MONTGOMERY COUNTY
PLANNING COMMISSION

March 13, 2024

Re: MCPC # 24-0041-001
Plan Name: 2405 - 2425 Maryland Road Conditional Use
(55 dwelling units on 1 parcels comprising approximately 1.65 acres)
Situate: Maryland Road (cross street: Computer Avenue)
Upper Moreland Township

Drawing Title
CONDITIONAL USE SITE PLAN

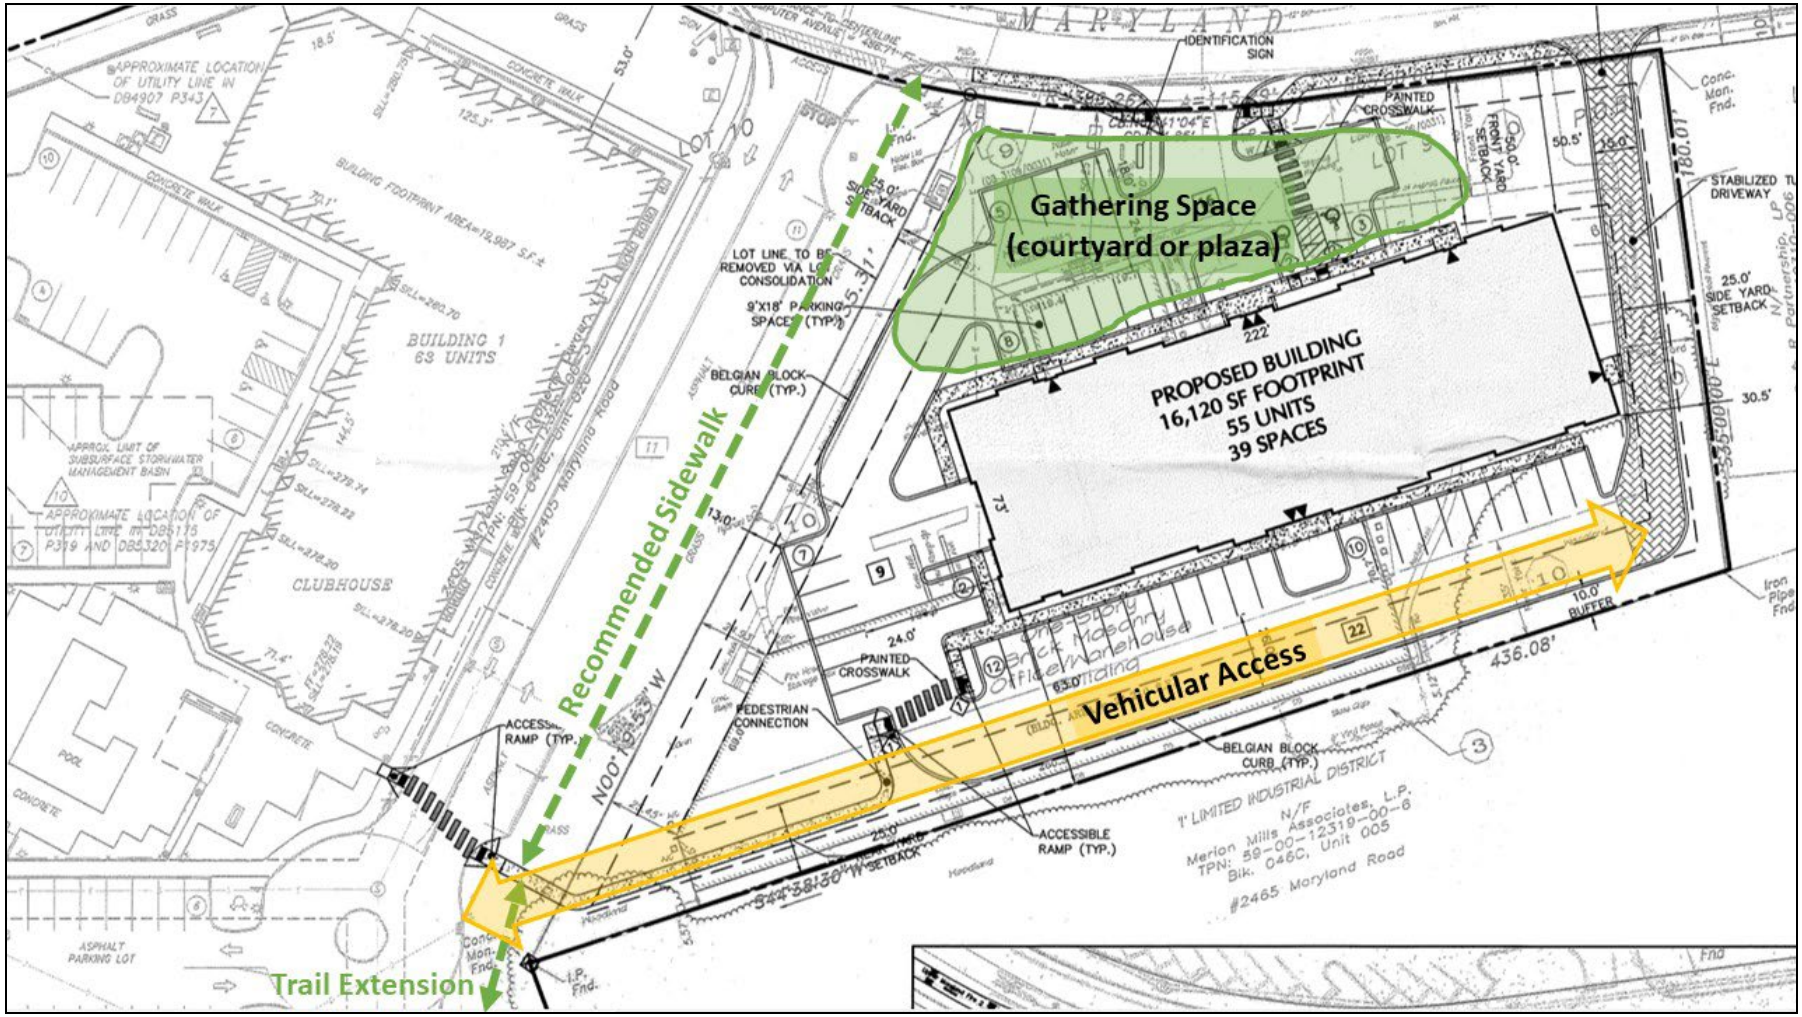
1. <u>Orientation</u>. The proposed building is sited in the middle of the lot and is not oriented towards the existing development or the street, but rather is inward facing. We believe that a more attractive development would be better connected to the surroundings (e.g. sidewalk, street, other buildings)

and would invite people to walk between the buildings and the shared amenities the development offers. To achieve a more cohesive development as a whole, we recommend that the applicant consider orienting the buildings more towards the street and cul du sal to interact with the rest of the development.

2. Blank Walls. The ground floor of the apartment building is proposed to be used for structured parking and storage. Based on the façade elevations provided, the exterior of the ground floor appears to primarily blank wall space, which detracts from the building's appearance. In order to create a more visually interesting and more human-scaled building, we suggest integrating openings or green wall features along the ground floor that could help to break up the façade and increase transparency and visual interest. Additional space between the walkway and the building to plant foundation landscaping would also help to break up the monotony of the large blank wall.

B. Streetscape. The existing Willow Pointe development has a sidewalk, building frontage along the sidewalk, and street trees, which work together to create an inviting streetscape. The proposed building does not appear to have any elements that would contribute to an inviting streetscape, and it is separated from the street by the garage access driveway. To create an inviting and walkable entrance into the development, we recommend adding a sidewalk along the existing access driveway into the Willow Pointe development, with street trees, which would also reflect the other side of the street.

C. Gathering Space. Based on the site plan provided, there do not appear to be any gathering spaces around the proposed building, as is required as part of the conditional use approval (§ 350-102.V(1)(m)). We recommend the applicant consider creating a common gathering space with seating and a central focal point, such as an entrance plaza or courtyard. Please refer to the attachment at the end of this letter for illustrations of these concepts.

A. Driveway Location. As the proposal is currently designed, there would be two breaks in Maryland Road for vehicular access. Having multiple curb-cuts along a short stretch of road is dangerous for both drivers and pedestrians, and is detrimental to a walkable environment. We suggest the applicant consider an alternate design for vehicular access to the site. We recommend retaining the emergency access, using the existing driveway as primary vehicular access to the site, and integrating the driveway for the proposed building off of the existing cul-du-sac. In addition to reducing the number of curb cuts and interruptions along Maryland Road, this design would have the added benefit of creating a more integrated and well-connected development overall.

If vehicular access was shared with the existing driveway, one of the curb cuts on Maryland Road could be removed and there would be an opportunity to create a gathering space (entrance plaza or courtyard) between the building and the road. Please refer to the attachment at the end of this letter for illustrations of these concepts.

B. Pedestrian Connectivity. A multi-use trail was constructed as part of the Willow Pointe development. The trail does not currently connect to a larger trail network. To extend the trail and connect future

residents to the trail and dog park amenities on the Willow Point complex, we recommend that the applicant extend the trail from the proposed sidewalks/paths of the new building to the existing trail.

Gathering Space
(courtyard or plaza)
PROPOSED BUILDING
16,120 SF FOOTPRINT
55 UNITS
39 SPACES
Recommended Sidewalk
Vehicular Access
Trail Extension
IDENTIFICATION SIGN
PAINTED CROSSWALK
BELGIAN BLOCK CURB (TYP.)
9'X18' PARKING SPACES (TYP.)
PEDESTRIAN CONNECTION
ACCESSIBLE RAMP (TYP.)
BUILDING 1
63 UNITS
CLUBHOUSE
POOL
ASPHALT PARKING LOT
MARYLAND
436.08'
10.0' BUFFER
25.0' SIDE YARD SETBACK
50.0' FRONT YARD SETBACK
STABILIZED TURF DRIVEWAY
